# **ROCKY FLATS ENVIRONMENTAL TECHNOLOGY SITE**

## **771 Closure Project Decommissioning Operations Plan Modification 5**

**August 8, 2003**

Figure 4. Building 771 First Floor Plan Demolition Concept

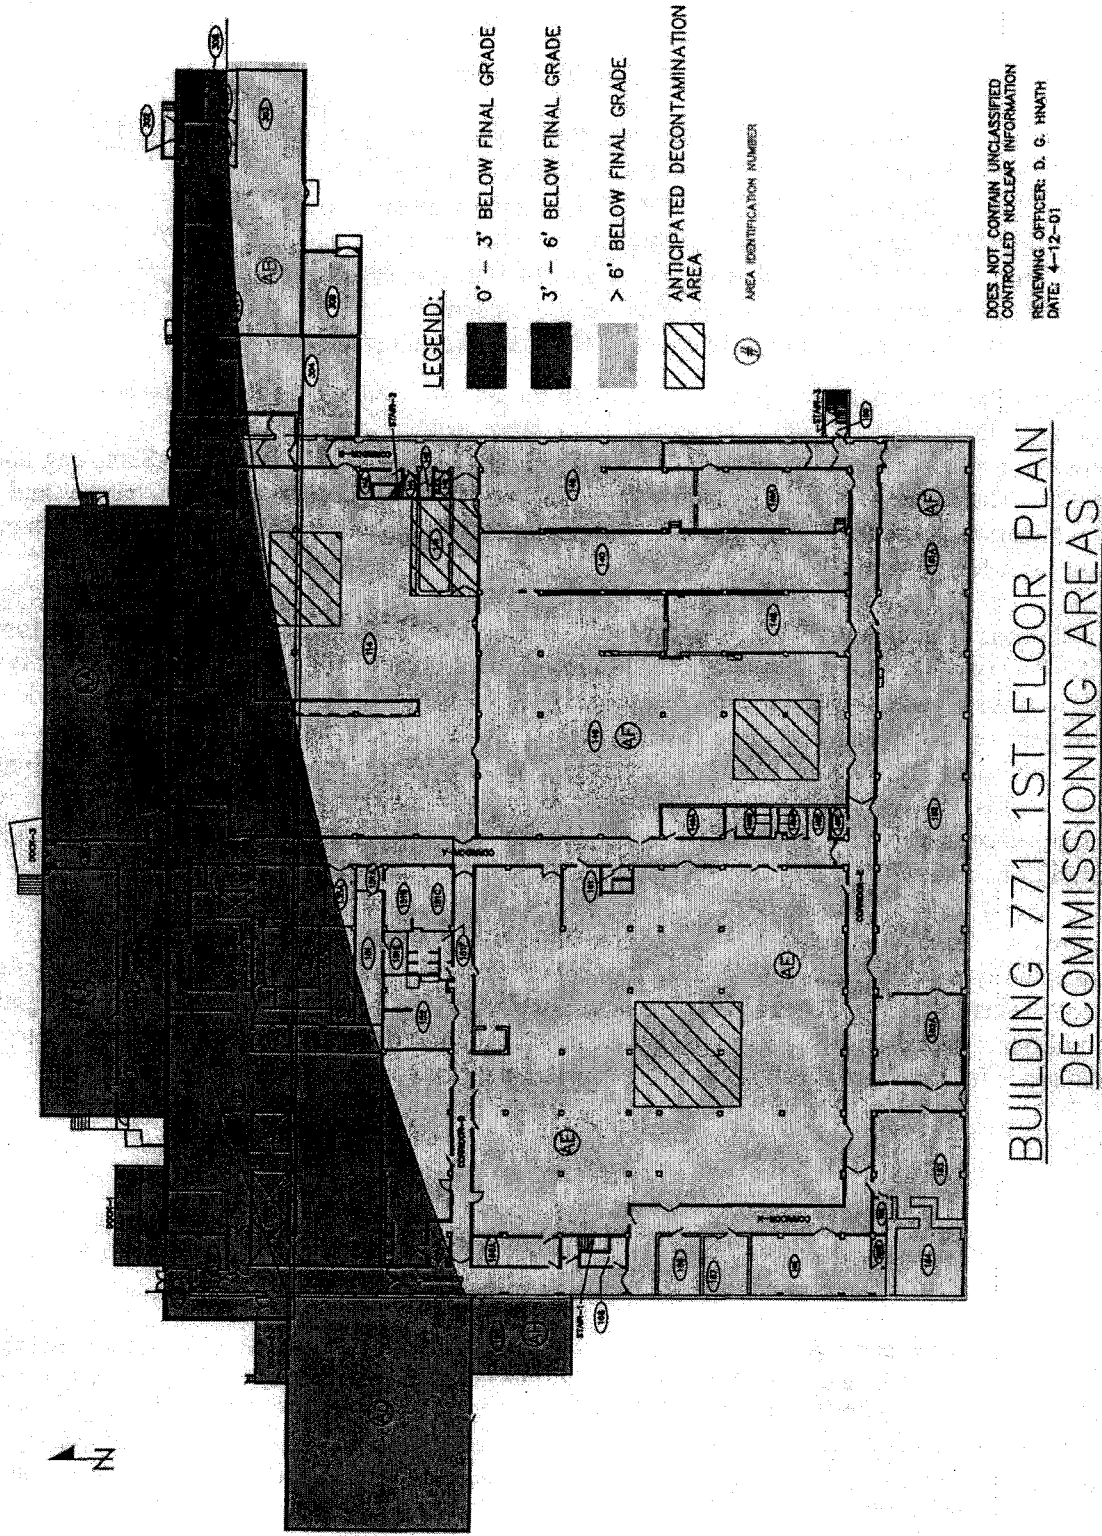
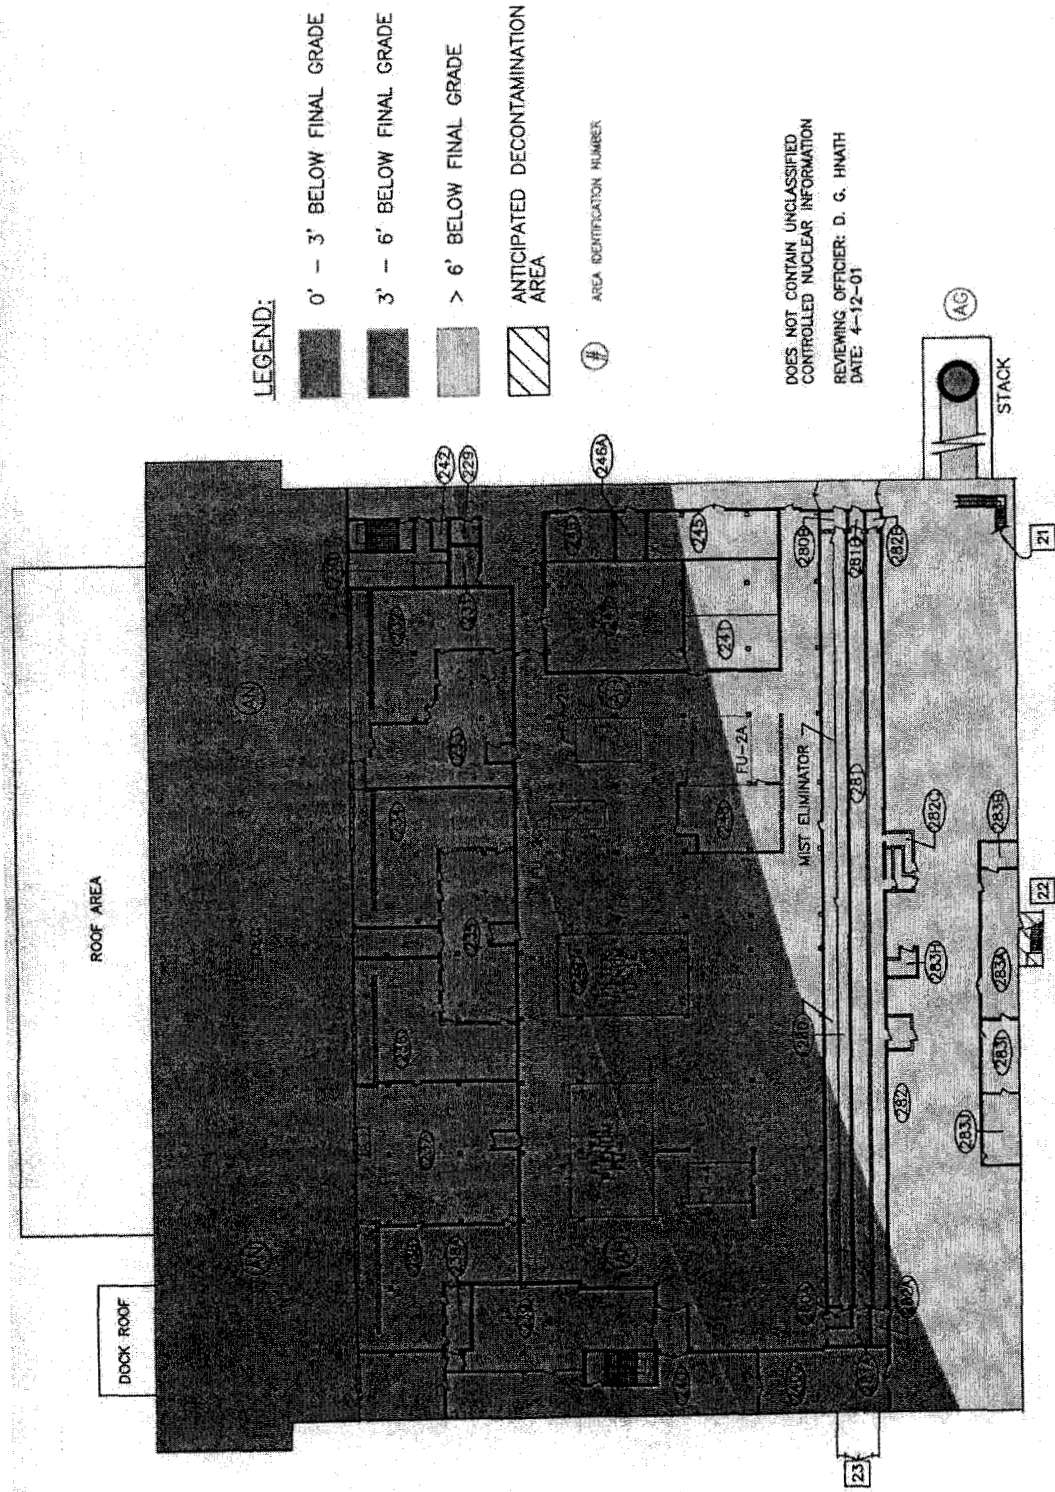
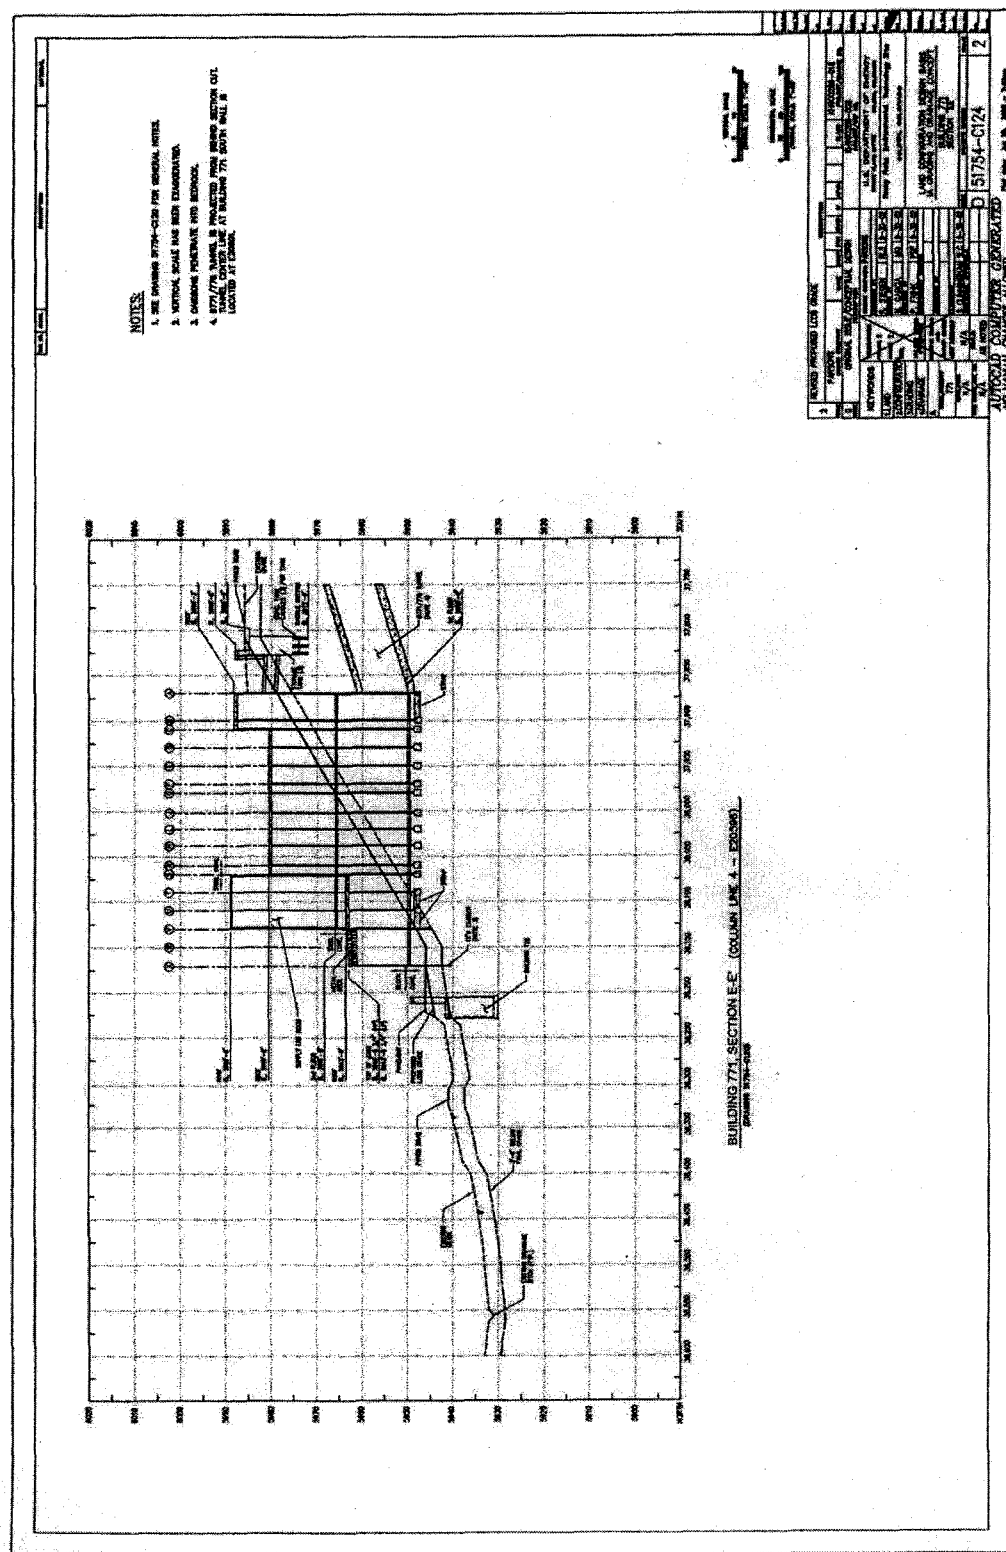
7	Figures 4 and 5 Update figures to reflect current proposed land configuration.	These figures will be updated for the final version of the document.
8	Figure 5 This figure is difficult to understand and needs, at the least, the floors labeled.	Floor labels will be added to the figure.
9	Section 4.7.1 It is indicated that steel plates may be utilized to "encapsulate" the remaining contamination. Steel plating must be removed and cannot be left after demolition. It is recommended that Instacote be considered rather than steel plate.	Instacote will be evaluated. There seems to be no technical reason for removing the steel plates. If the structural steel can remain in the facility, the minor amount of steel plates should have little or no adverse affects. However, steel plates will not be used, and the document has been revised.

Figure 5. Building 774 Floor Plan Demolition Concept

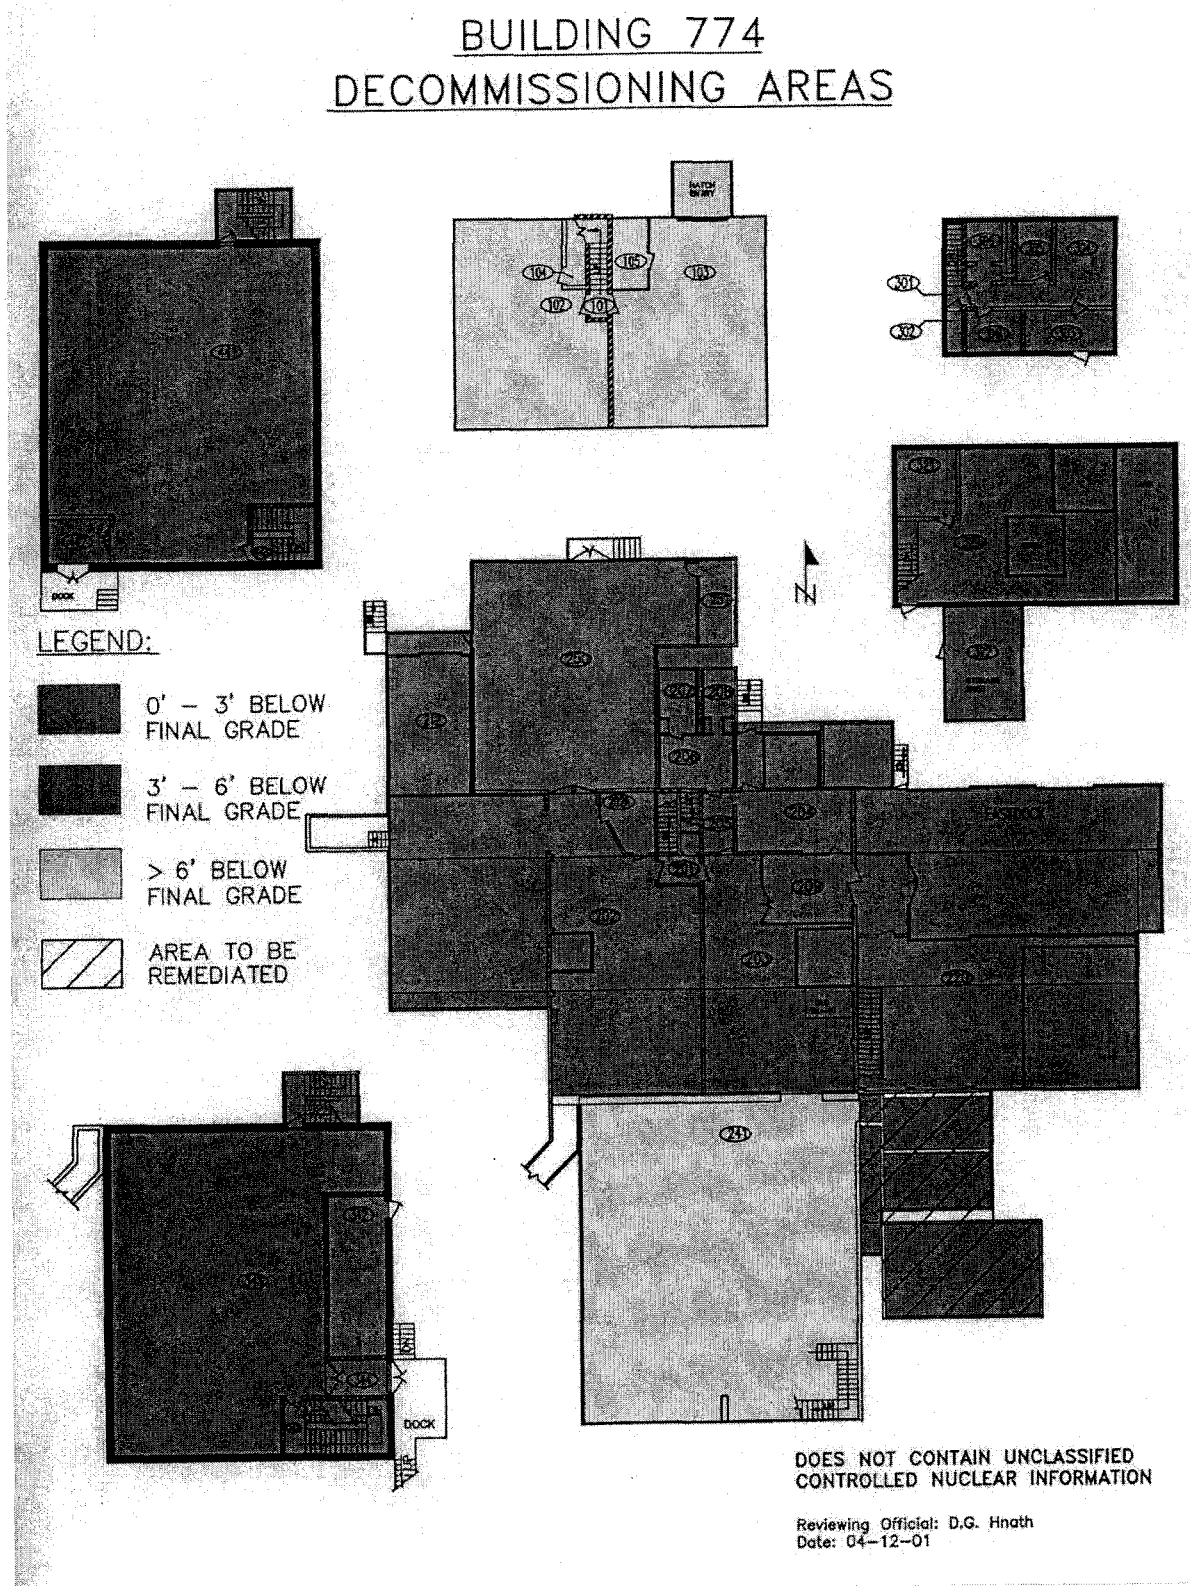
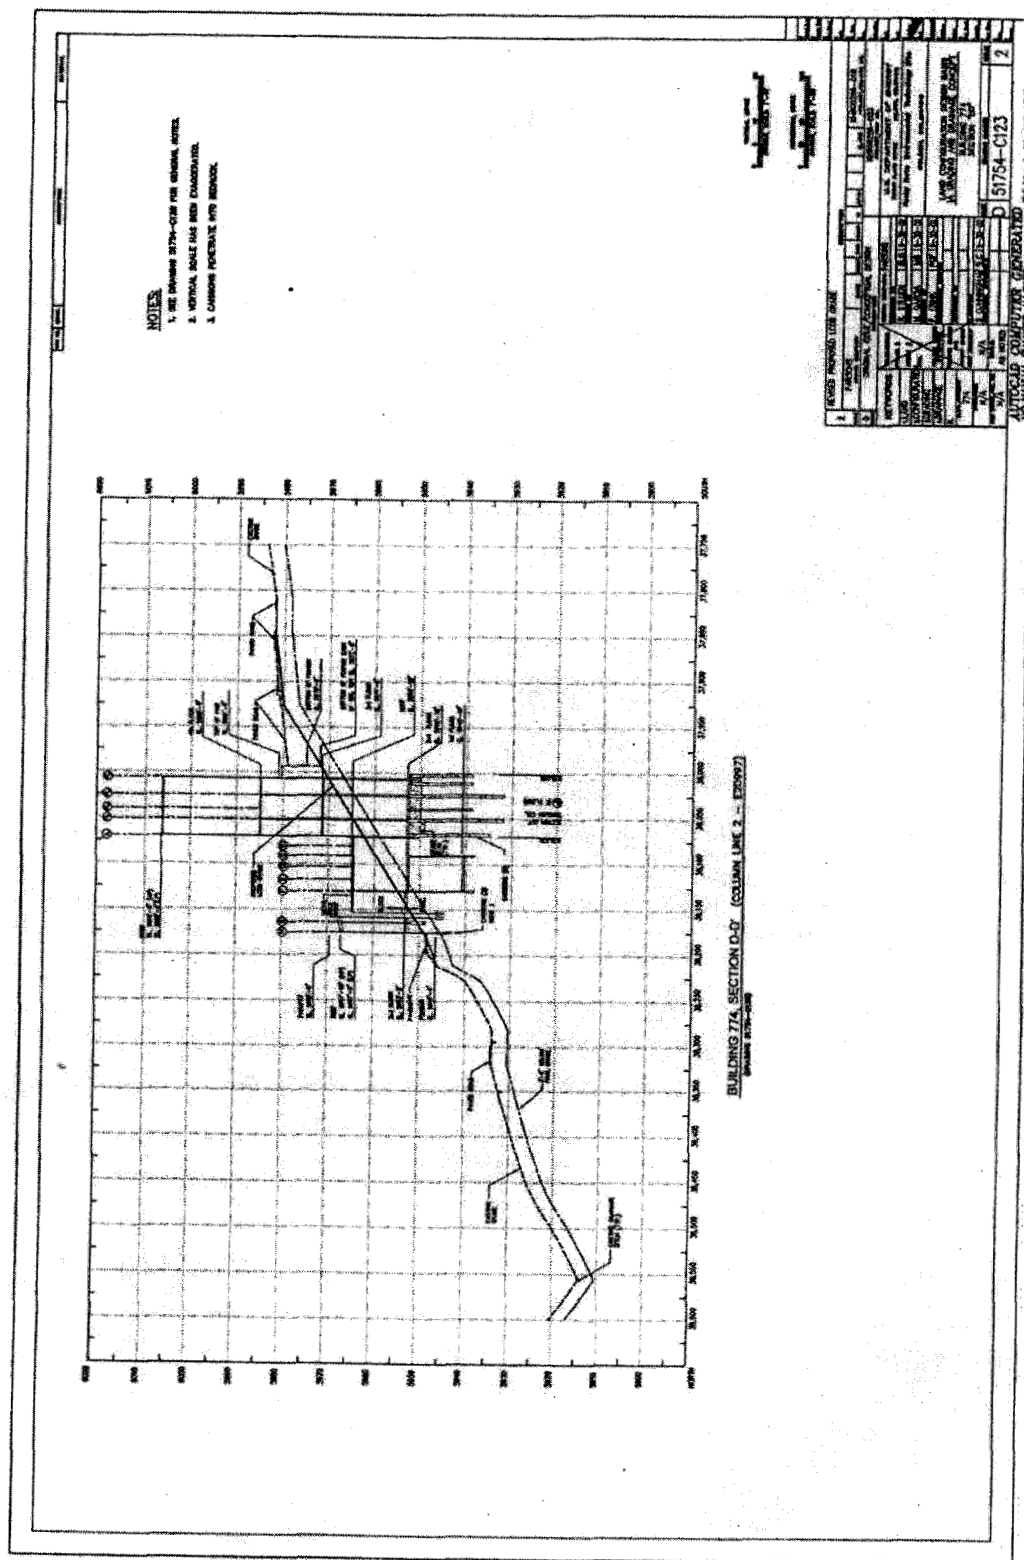
5	<p><b>Figures</b></p> <p>The text in Section 4.7.1.8 (Demolition of the Main Building 771 Structure) describes the planned three-sided configuration for the Building 771 foundation area after demolition, and states that "Figures 4 and 5 provide an aerial view of this concept." Figures 4 and 5 provide a useful aerial view, but they do not show the three-sided configuration referenced. During the Coalition staff briefings, Site representatives distributed side-view diagrams of the post-demolition condition of B771 and B774. It would be helpful to include these diagrams so that the reader has a better understanding of the depth of the buildings and how much of the structures will be demolished.</p>	<p>These figures were added to the document.</p>
